BALLARAT SEWERAGE AUTHORITY.

Sewerage Area No. 22 MASTER PLAN

Drainage Plan No. 1622

AMENDED PLAN OF DRAINAGE [M.P.1622]

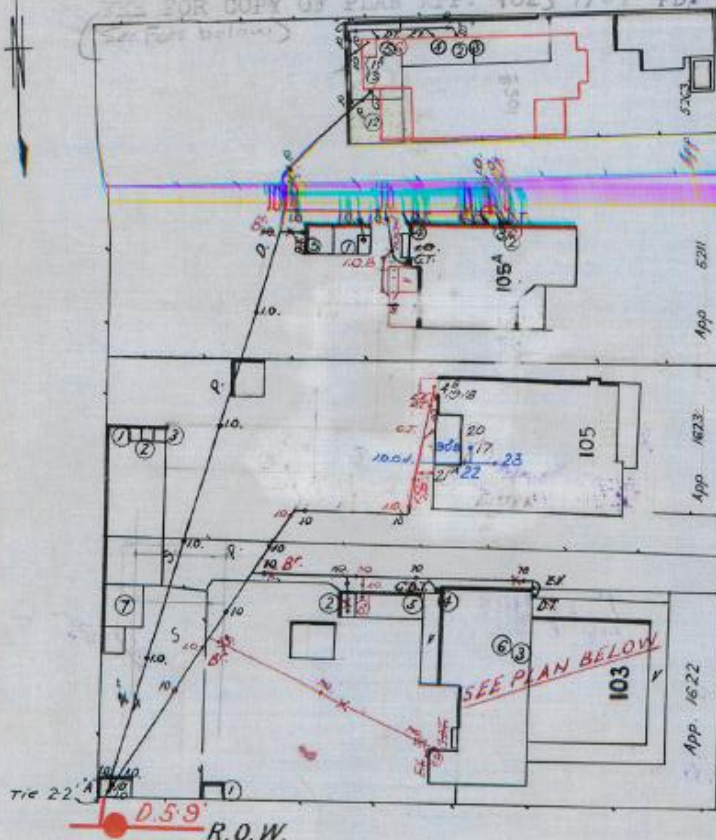
1. Closet to be abolished.
2. Closet external proposed.

4. Sink.
5. Wash Troughs - regulation pipe to be provided.
6. Lavatory Basin to be replaced.
7. Stable to be abolished.

- 1, 2, 3. Closets to be abolished.
4. Closet external proposed.
5. Bath to be abolished.
6. Sink to be abolished.
7. Sink to be moved to 8.
9. Wash Troughs.
10. Lavatory Basin proposed.
11. Lavatory Basin to be replaced.
12. Stable to be paved with bricks on edge on 3rd ear or ashes grouted full depth with cement mortar and graded to 8 ft.
13. Stable to be abolished.
14. Manure Bin to be repaired and cover provided. (First Floor)

15. Bath to be replaced. No Lead safe required.
 16. Lavatory Basin to be replaced. No Lead Safe required.
- S.P.D. near trees to be surrounded with concrete or trees to be grubbed out.

G.D.T. & G.T. to be built up with radial bricks or cement concrete rendered internally and on top to a smooth surface, and 15 in. internal diameter. Tap and apron to be provided.

o. Lavatory Basin to be abolished.

12. Stable to be abolished.

- 4. Closet external to be abolished.
- 8. Sink to be abolished.
- 9. Wash Troughs to be abolished.
- 10, 11. Lavatory Basins to be abolished. (First Floor)
- 15. Bath to be abolished.
- 16. Lavatory Basin to be abolished.
- I.V.'s to be abolished.
- Drain and Trap to be sealed as directed.

4A. Closet external to be moved to 4B.

- 1. Closet external to be abolished.
- 2. Bath to be abolished.
- 3. Basin to be abolished.
- 4. Sink to be abolished.
- 5. Troughs to be abolished.
- S.P.D. under building to be taken up.
- S.P.D. from "A" at 103 Lyons Street to "B" at 105 Lyons Street to be laid at a grade of 1 in 66 without J.U.

- 1. Closet external proposed (door to face East).
- 2. Bath proposed.
- 3. Basin proposed.
- 4. Sink proposed.
- 5. Troughs proposed.

S.P.D. from "B" to "C" to be laid at 1 in 66.

G.T. to be built up with radial bricks or cement concrete rendered internally and on top to a smooth surface, and 15 in. internal diameter. Tap and apron to be provided.

1. Closet external to be abolished.

- 8. Closet external proposed.
- 9. Sink proposed.
S.P.D. near trees to be surrounded with concrete or trees grubbed out.

- 6. Closet internal proposed. Permanent and efficient light and ventilation to be provided. No storage tank to be provided. (Request 21/8/61).
S.P.D. not in use to be abolished.

- 21. Closet internal proposed. Permanent and efficient light and ventilation to be provided. No storage tank to be provided. (Request 22/9/61).
S.P.D. under building to be surrounded with concrete.

- 5. Troughs to be abolished.
- 7. Trough proposed.
- 8. Washing Machine proposed.
S.P.D. not in use to be abolished and O.B. sealed as directed.

- 21A. Closet internal proposed. Permanent and efficient light and ventilation to be provided. No storage tank to be provided. (Request 22/9/61). Pan to be vented off heel of C.I. I.O. bend.

- 7 Bath to be abolished
- 0 Basin to be renewed
- 2 Closet proposed
- 3 Shower proposed

- 1A. Closet to be made internal. Permanent and efficient light and ventilation to be provided. No storage tank to be provided. (Request 12/12/67). Pan to be vented as directed.
- 3. Basin to be renewed.
- 4. Sink to be renewed.
- 5. Troughs to be renewed.
- 6. Washing Machine proposed.

- All existing fittings to be abolished.
- 1. Closet internal proposed
- 2. Closet internal proposed
- 3. Bath proposed
- 4. Basin proposed
- 5. Basin proposed
- 6. Shower proposed
- 7. Shower proposed
- 8. Sink proposed
- 9. Trough proposed
- 10. Washing Machine proposed
- S.P.D. not in use to be abolished and O.B.'s 2 No. sealed as directed.

New 100mm point of connection to be constructed in sewer main by the Authority at owner's expense after necessary excavation by owner. Authority requires 48 hours notice before excavation will be inspected.
